SUNDRY NOTICES AND REPORTS ON WELLS

Nash Unit #29

**NASH UNIT #29 SWD
EDDY COUNTY, NEW MEXICO
JANUARY 20, 2010**

**Nash Unit #29
30-015-29434
XTO Energy
January 14, 2010
Conditions of Approval**

XTO ENERGY - PROPOSED AFTER 1/2010 WORK

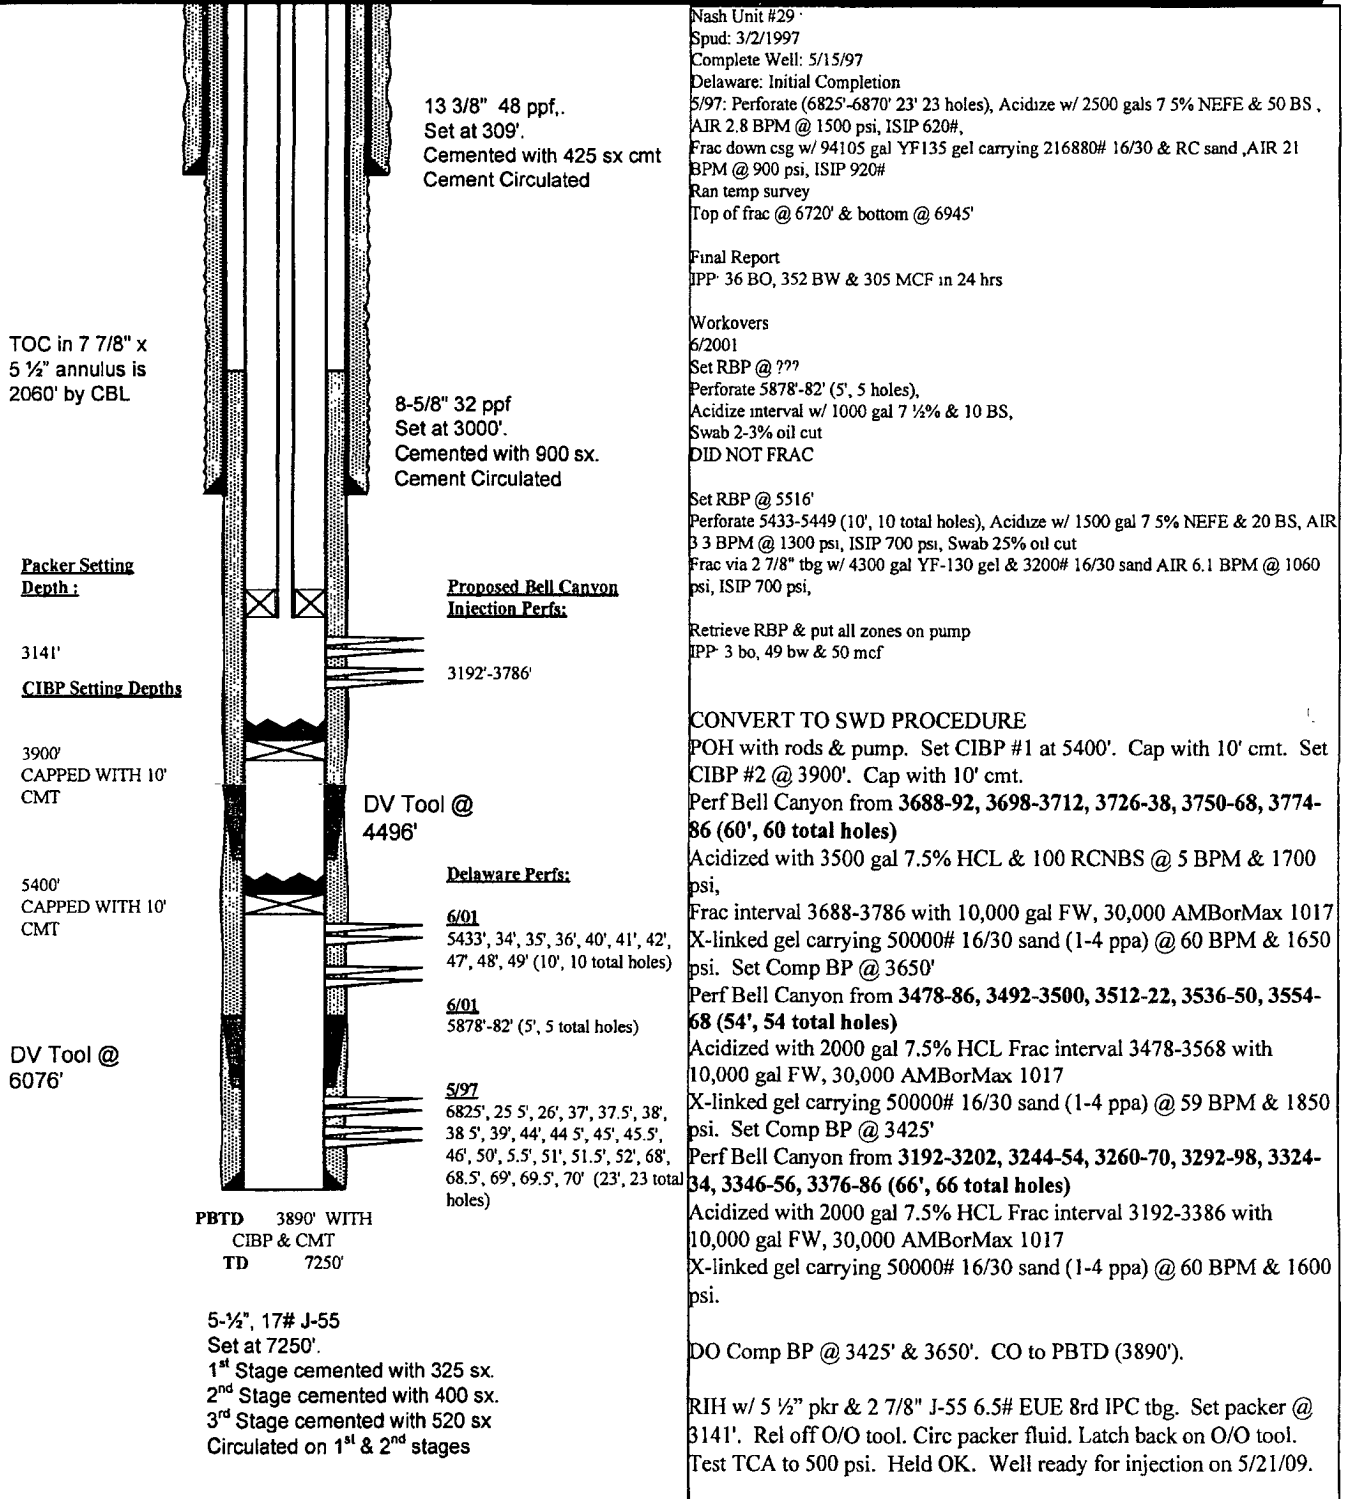
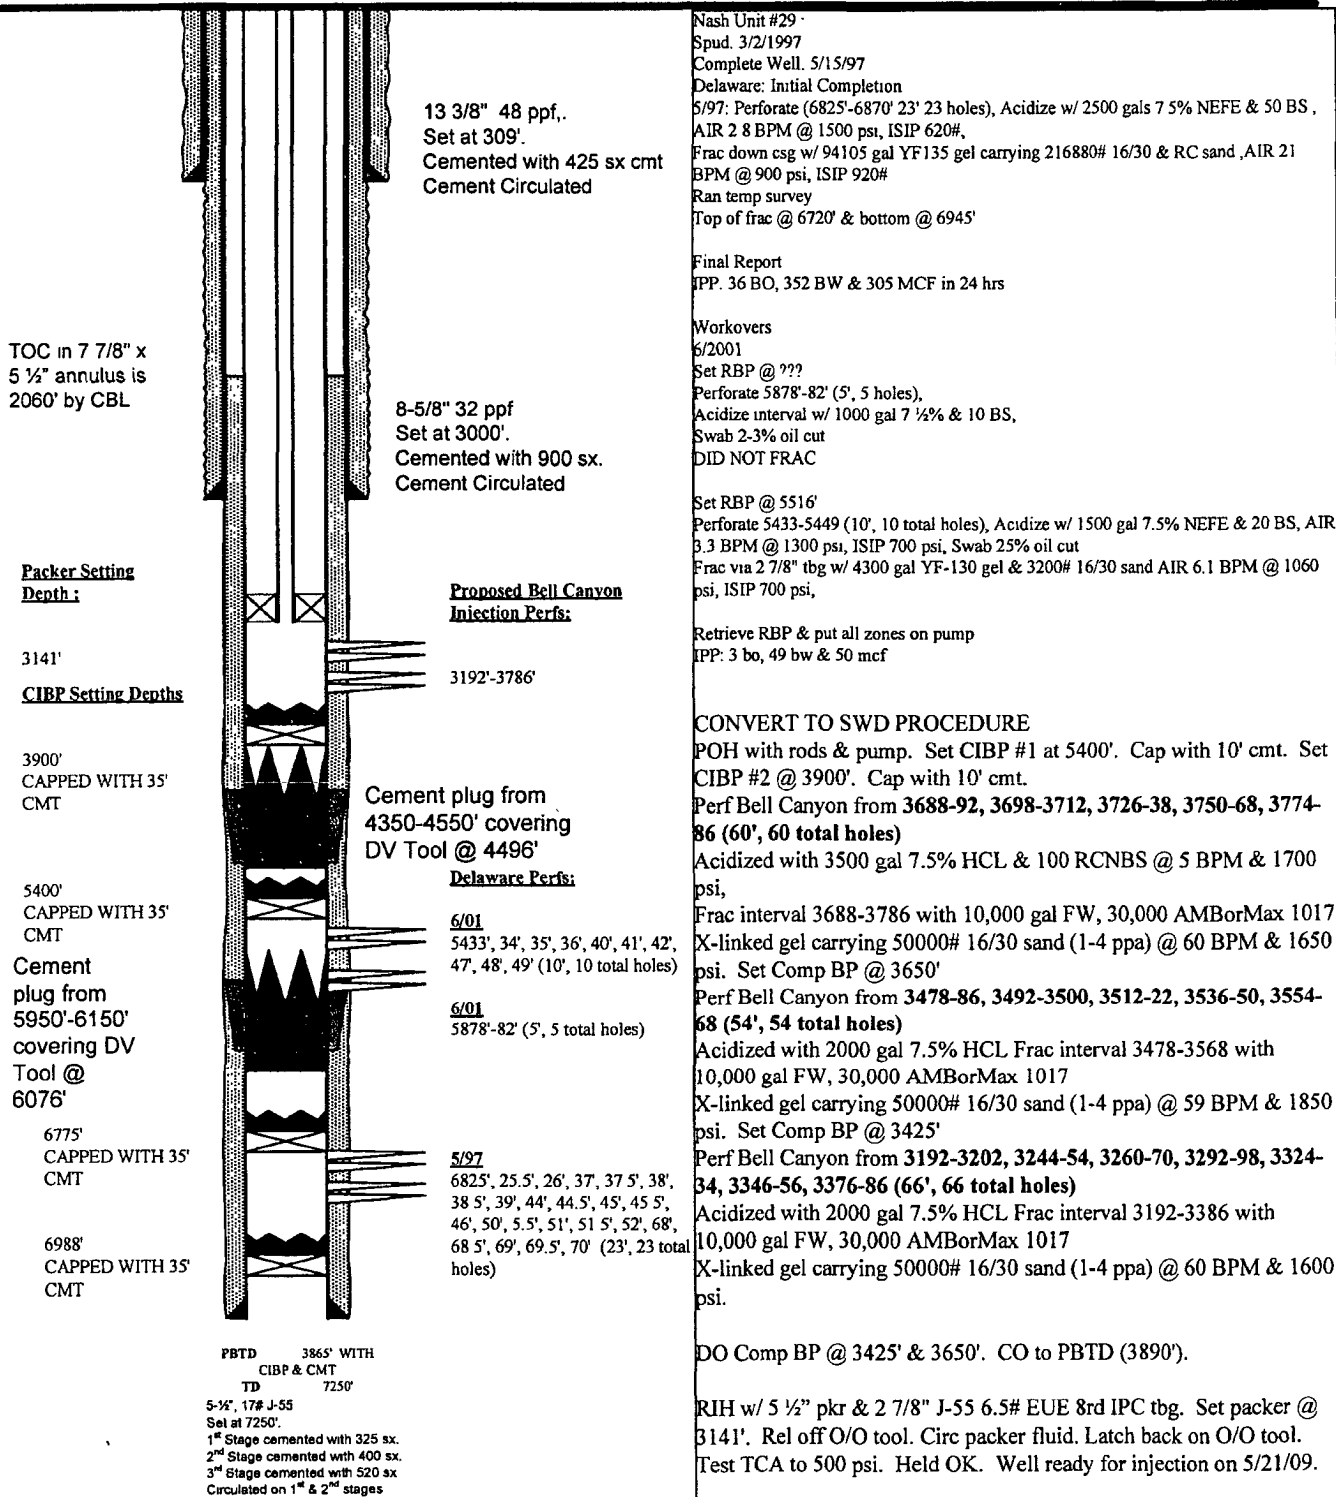
**Nash Unit #29
30-015-29434
XTO Energy
January 27, 2010
Conditions of Approval**

NOTE: THE STATEMENT THAT ADDITIONAL CONDITIONS WERE ADDED ON JANUARY 14, 2010 IS INCORRECT. THESE CONDITIONS WERE A REITERATION OF THOSE ORIGINALLY SENT AUGUST 8, 2009. HOWEVER, THE OPERATOR HAD ALREADY PERFORMED CONVERSION WORK ON A FEDERAL WELL BASED ON AN APPROVAL BY NMOCD. COPY OF ORIGINAL COA FROM THE SUNDRY OF APRIL 8, 2009 APPROVED AUGUST 8, 2009 IS ATTACHED. OPERATOR WAS INFORMED PRIOR TO APPROVAL IN AUGUST THAT BLM WAS REVIEWING THIS DOCUMENT AND MIGHT NOT APPROVE THE CONVERSION.

- 3. Work completed in May 2009 was done prior to approval. Well has not been plugged back properly. Work required in original approval of August 8, 2009 shall be completed prior to the well being used as an injection well. This will be the remedy for the Incident of Non-Compliance that has been issued.**

- 4. Bone Spring plug will be done by setting a CIBP at 6988' with 35' of cement. Top of plug will be at approximate depth allowed when drilling Delaware wells.**

- 5. CIBP will be set at approximately 6775' (may vary somewhat in depth due to collars) with 35' of cement bailed on top.**
- 6. Plug required across DV tool at 6076'. Plug to be set from 6150 – 5990' and tagged. Plug to be tagged a minimum of 50' above top of DV tool. Plug to be 160' in length and a minimum of 25 sacks.**

- 7. CIBP at approximately 5383' (may vary somewhat in depth due to collars) with 35' of cement bailed on top.**
- 8. Plug required across DV tool at 4496'. Plug to be set from 4550 – 4405' and tagged. Plug to be tagged a minimum of 50' above top of DV tool. Plug to be 145' in length and a minimum of 25 sacks.**

- 9. CIBP at approximately 3900' with 35' of cement bailed on top.**
- 10. Proceed with proposed procedure.**
- 11. Subsequent sundry required detailing all work and when well was placed on injection.**

- 12. New completion report required for injection zone.**
